GOVERNMENT OF PAKISTAN
PRIME MINISTER'S OFFICE
NATIONAL DISASTER MANAGEMENT AUTHORITY
ISLAMABAD

F. No. 787/NDMA/IA&PD/2024

Subject: **Infrastructure Advisory 04/24 – Post-Collapse Mahandri Bridge and Landslide Recommendations**

Figure 2 Recommended Water Flow Path

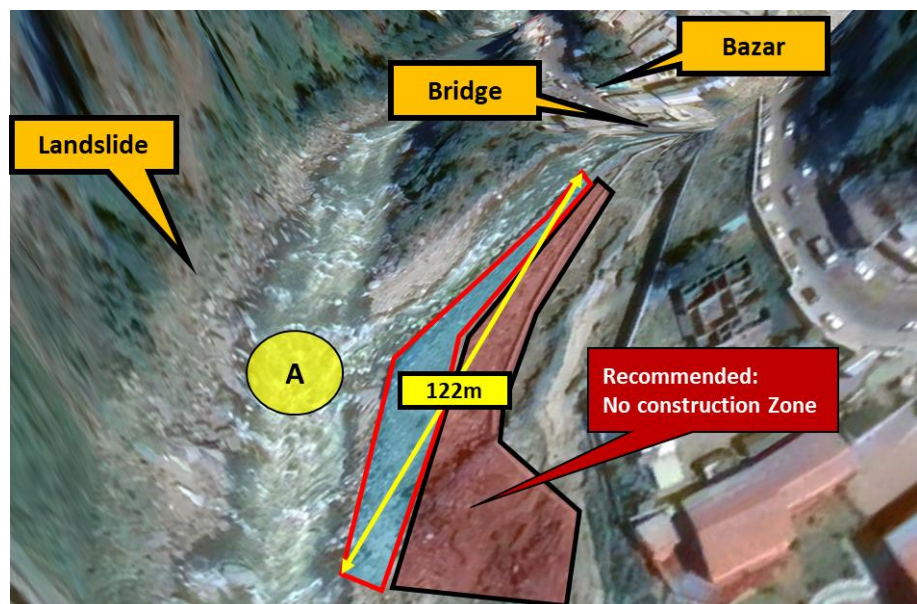
- (1) Desiltation is recommended at the area marked in Figure - 2 in order to increase the capacity of the water channel. This will result in smooth merging of both streams in addition to preventing turbulence at point A marked on the map.
- (2) Restricting new construction in high-risk prohibited zone identified as landslide prone area
